DEBUR AND BREAK SHARP EDGES	DO NOT SCALE DRAWING	REVISION 4
	TITLE: Suspension linkage	
MATERIAL:	DWG NO. Suspension linkage	A4
WEIGHT:	SCALE:1:2	SHEET 1 OF 1

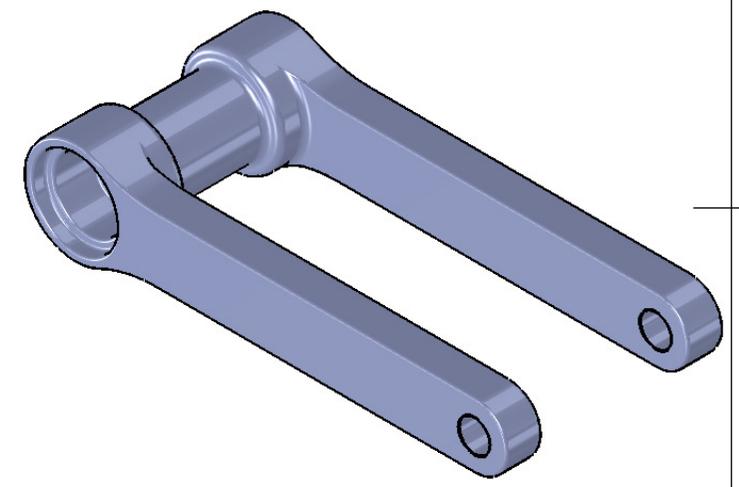
Please check that all dimensions are correct!

There is a 1 mm radii on all inner surfaces. This will prevent high tension in these areas. The bearings will have a cut out to accomodate these radii.
